From: Michael Eastham
Sent: 16 January 2018 13:43
To: Planning.Responses
Cc: Lisa Coney; Nicola Spencer
Subject: FW: Swanbourne Park - AL/82/12 - LEAP/LAP Proposals

Thank you for submitting LAP and LEAP proposals dwg BSH17576 31 A

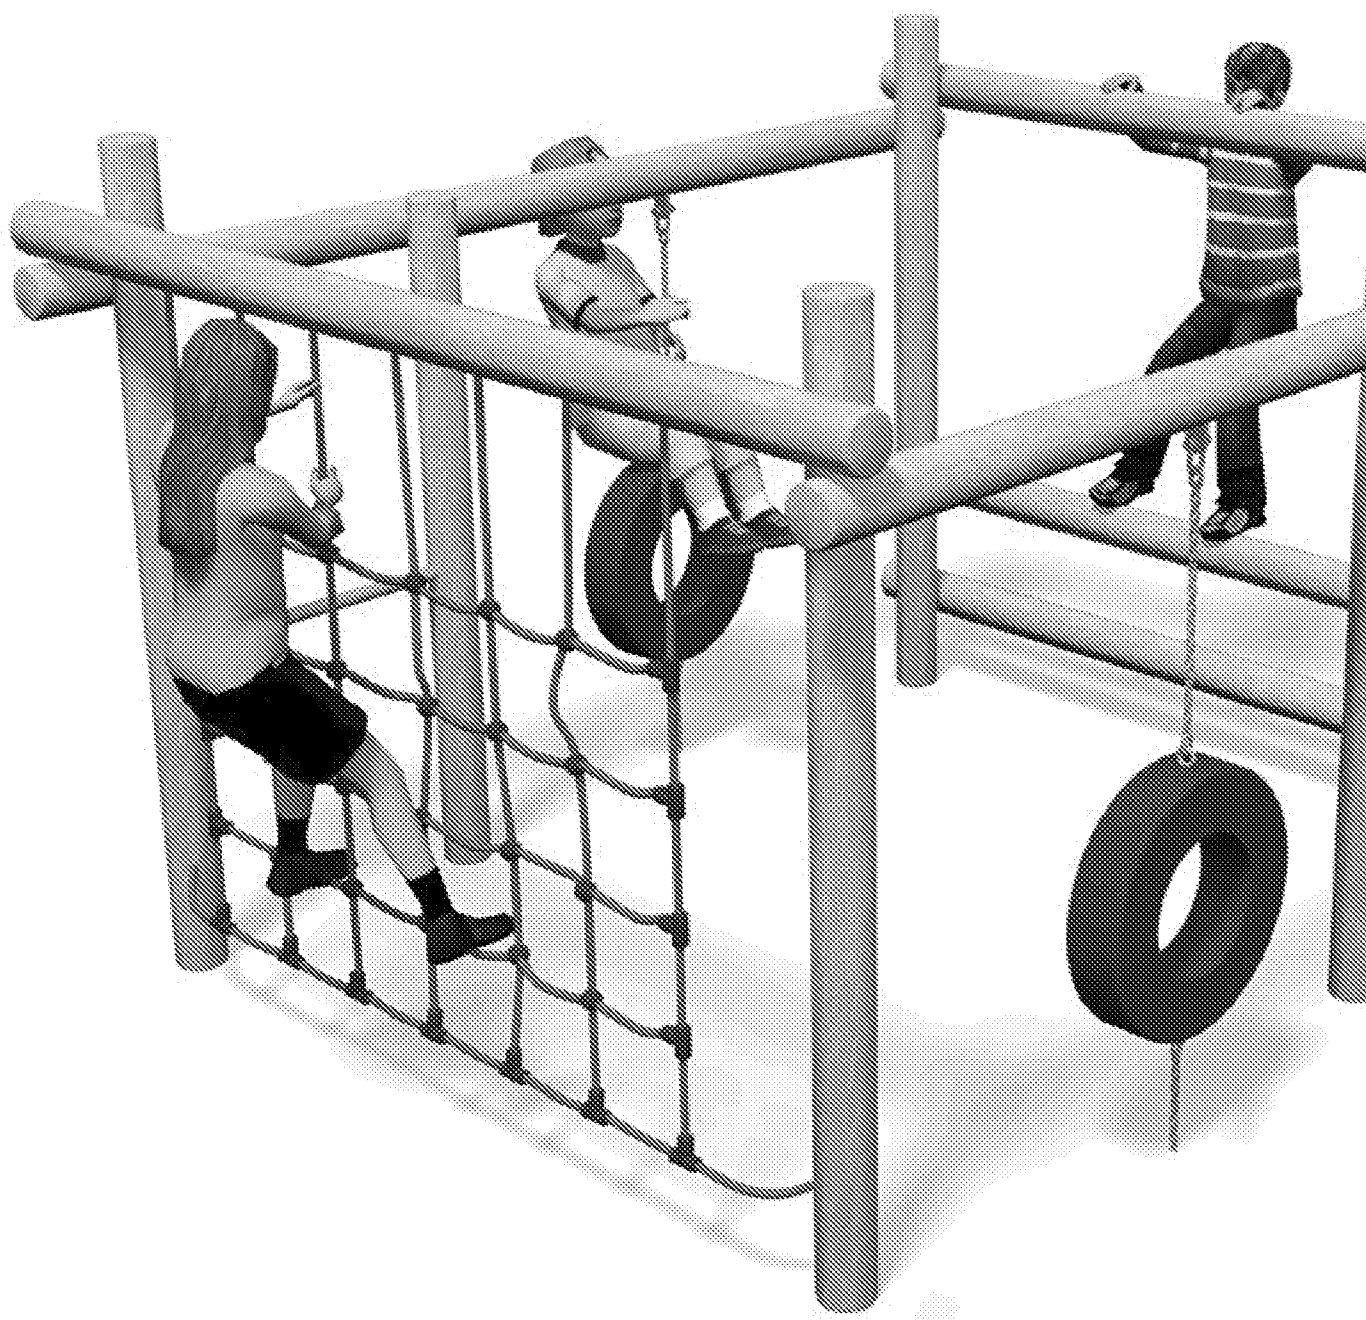
Please see below the climbing frame picture as stated in my previous email.

The LEAP area has been designed with 5 pieces of equipment, each focusing on a different movement (swinging, spinning, sliding etc.). We are proposing to keep these and add a piece of equipment to focus on the climbing movement. I have attached a picture of the piece of equipment for consideration. This will be centred in the LEAP area as it is larger than the other items. The fence type is 1m galvanized bowtop fence in black – legend/key specifies this.

Thank you for the updated detail re play equipment for the LEAP. In principal its fine in that it ticks the play experiences number that we were looking to achieve. Although there is technically no specific age range pinned to this other than 'specifically for children who are beginning to go out and play independently' the scheme as a whole is verging on the lower age range so generally we wouldn't want to see equipment for a LEAP aimed at too lower an age range.

I am happy in this instance for you to update with the revised central climber unit as submitted, which will then form an approved LEAP proposal.
